Comment #326, #182, #184 resolution.  
 Make the changes in the following order:

Figure 97-2

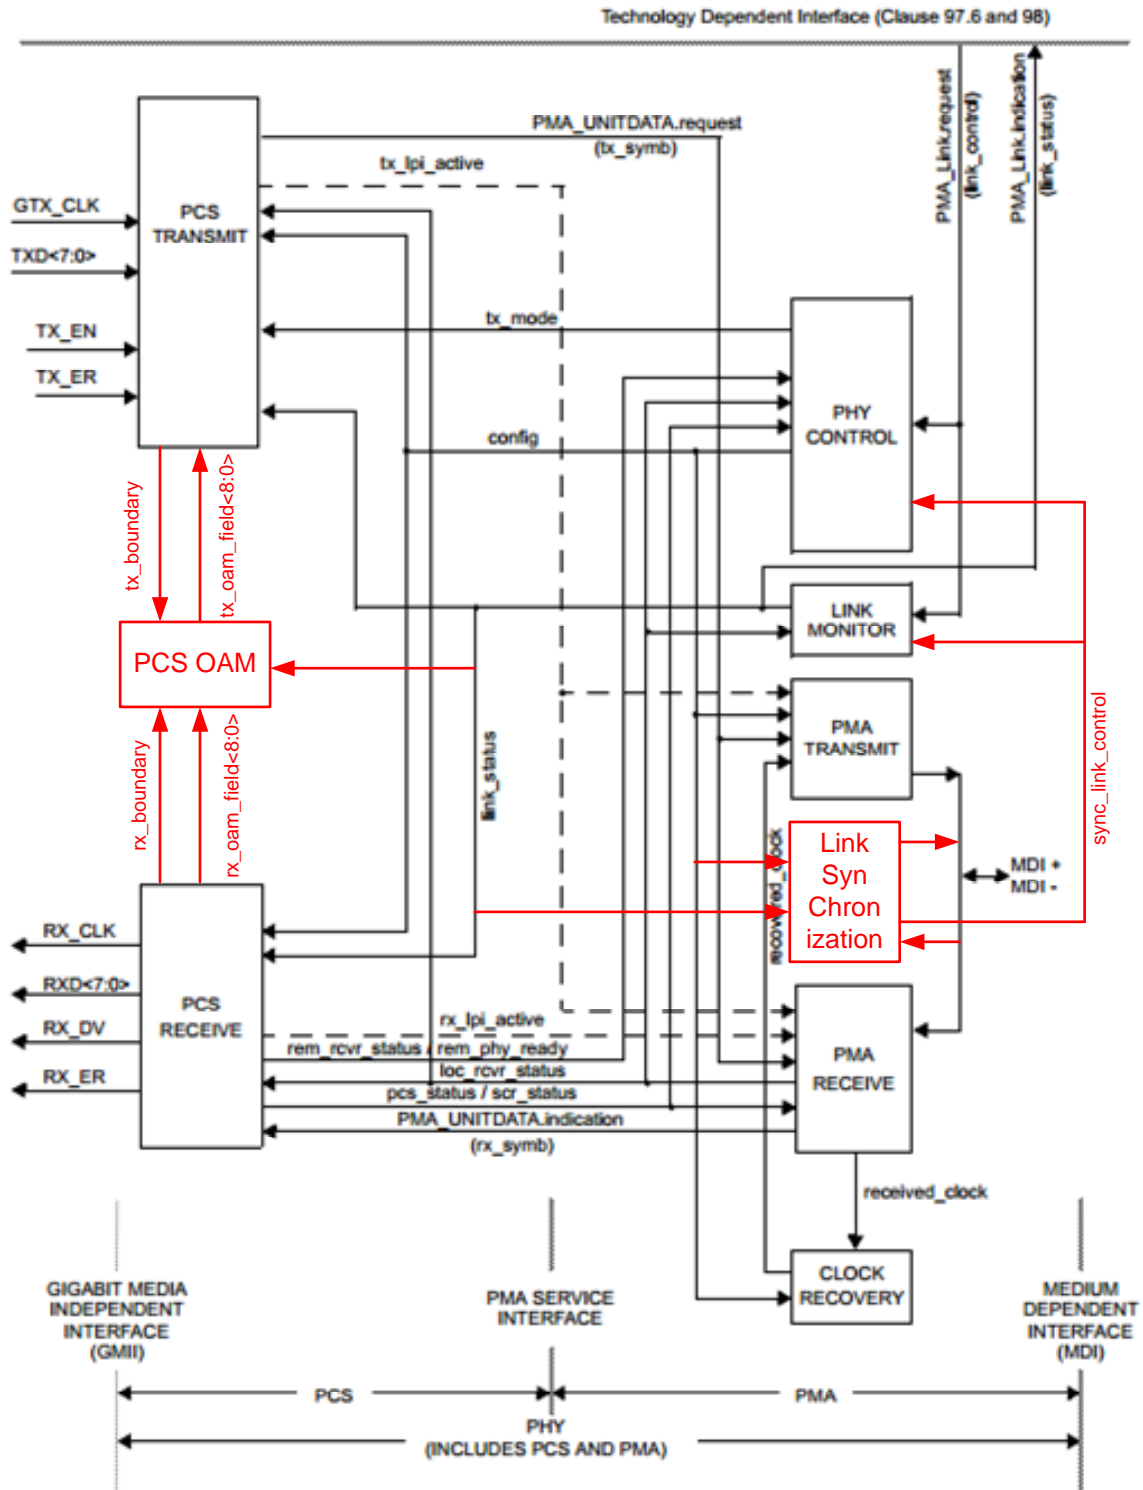
1) make changes to the following 3 diagrams as sketched
